ADDENDUM 1

Subject: BID# 13-062, El Paso County Colonia Revolucion Water System Improvement Pipeline Project

ADDENDUM NO: 1

PROJECT NAME: Bid #13-062, El Paso County Colonia Revolucion Water System Improvement Pipeline Project

B1 SERVICE LINE 3/4" AND 1" INSTALLATION
NTS

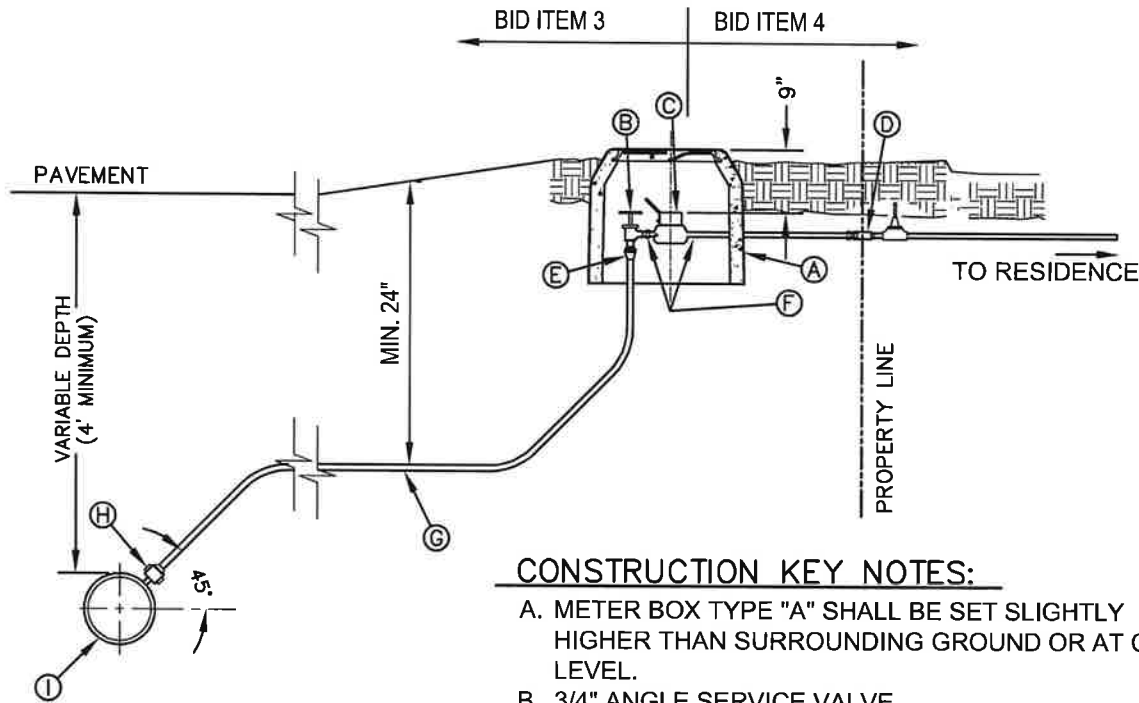
24. 3.3 A & B require that 'Meter shall be provided and installed by Contractor or Plan sheet CP-502, Detail B1 shows that the water meters shall be provided and installed by EPWU.

- A. Sheet CP-502 – Replace Detail B1 per attachment.

Response: On drawing sheet CP-502, Detail B1, Construction Key Note C, replace reference “by EPWU” to “by Contractor”. Section 0125 Measurement and Payment, Item 3.3 A and B wording “Meter shall be provided and installed by Contractor” is correct.

- A. METER BOX TYPE "A" SHALL BE SET SLIGHTLY HIGHER THAN SURROUNDING GROUND OR AT CURB LEVEL.
- B. 3/4" ANGLE SERVICE VALVE.
- C. WATER METER TO BE FURNISHED AND INSTALLED BY CONTRACTOR.
- D. DUAL CHECK BACKFLOW PREVENTER SHALL BE INSTALLED ON THE OUTLET SIDE OF THE METER.
- E. END FLARE OF SERVICE LINE.
- F. INLET AND OUTLET COUPLING.
- G. 3/4" COPPER TYPE K SERVICE LINE.
- H. 5/8" X 3/4" CORPORATION STOP
- I. WATER MAIN
